MTEC Consultants Ltd
PO Box 878
ROTORUA

**NOTICE OF DECISION REGARDING VARIATION TO APPROVED
SUBDIVISION CONSENT**

Consent No.: 63 05 026
Applicant: Pioneer Property Trust Ltd
Location of proposal: Western Road
Legal Description: Lot 17 DP 336769 and easement over Lot 16 DP 336769
Proposal: Proposed amendment to extend Pioneer Rd to allow access for future development, the vesting of Lot 31 in RDC as Drainage reserve, consequential changes including the removal of easements and rearrangement of lots.

DRAWING NO: 175781-R-P-D002			
SHEET NO: 01			
ISSUE: G

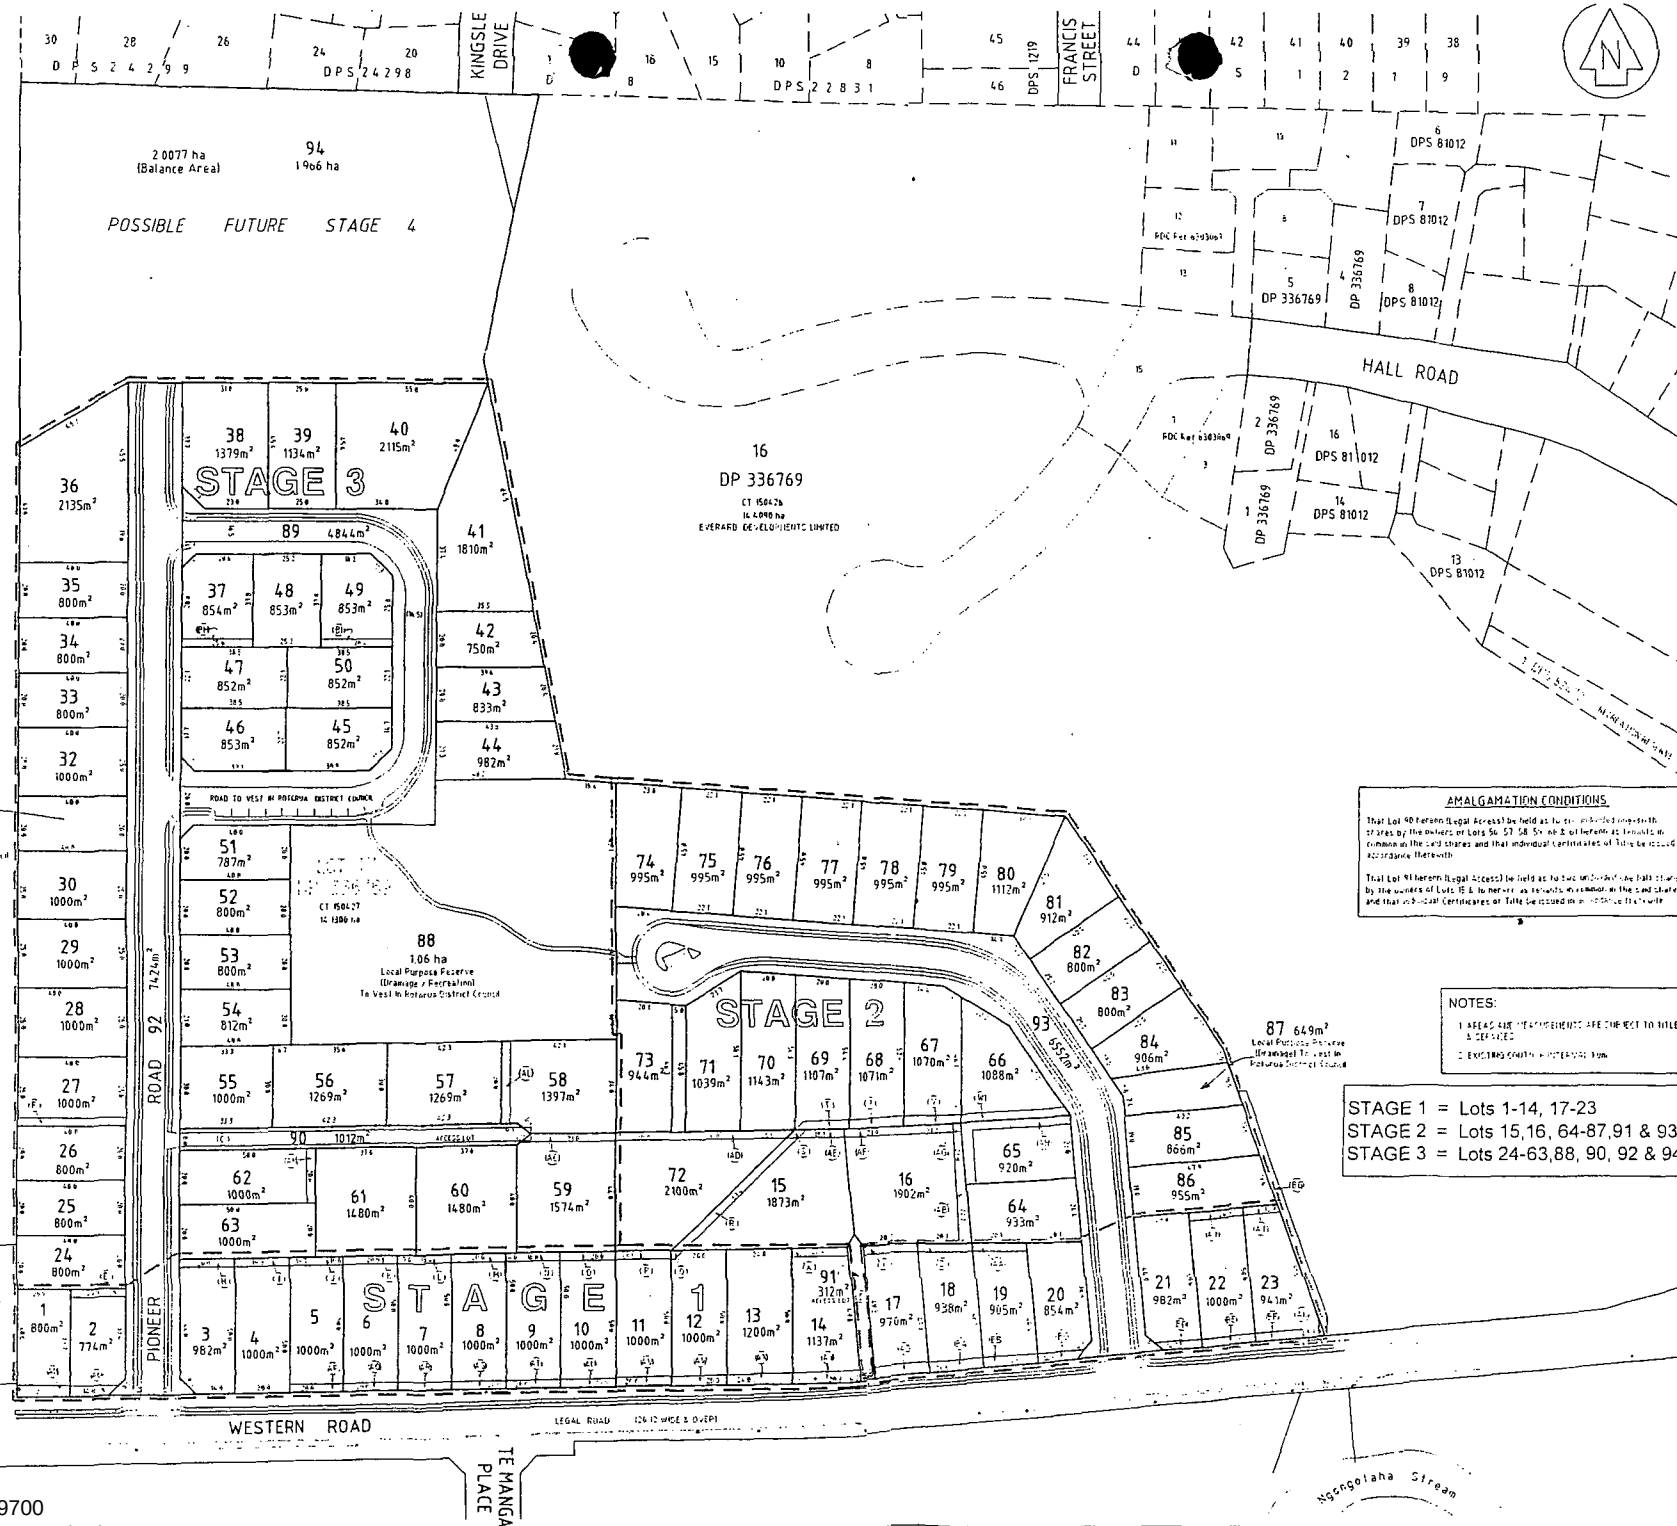
26. That the Land Transfer Plan be prepared in accordance with the preliminary plan of subdivision prepared by MTEC Consultants Ltd, numbered 175781-R-P-D002, Sheet number 01 Issue G and dated 27/07/07 in so far as it relates to Stage 3 - Lots 24 – 63, 88, 90, 92 & 94 *unless amended by conditions of this consent.*

40. That the overland flow paths are identified and shown as easements in favour of Council.
41. That Lot 31 *shall vest in Council as Drainage Reserve and shall be constructed to contain the flows from a 1% AEP storm event.*

- the road to be extended to provide access for future Stage 4 to Pioneer Rd instead of to Hall Rd via the land to the east of this subdivision;
 - removes the need for overland flowpath easements; and

- confirms that Lot 31 will be vested in Council as Drainage Reserve.
2. Additional earthworks proposed will allow the construction of the road up the steep slope to the upper level of the development. Stage 4 will be the subject of a subdivision consent. The draft layout for future development - Stage 4 shows that a turning head can be provided. In approving this variation it has been noted that an application for consent for earthworks and stormwater discharge has been lodged with EBOP.

4. **The removal of the overland flow path through Lot 30 and the provision of Lot 31 as a separate Drainage lot allows the lot to be designed to contain overland flows from significant storm event.**

- (b) Lot 31 is to be shaped and provided with a concrete base (channel) and finished to a mowable standard.
- (c) A turning head at the end of the road is not required for this stage of development as turning is provided by the loop road.
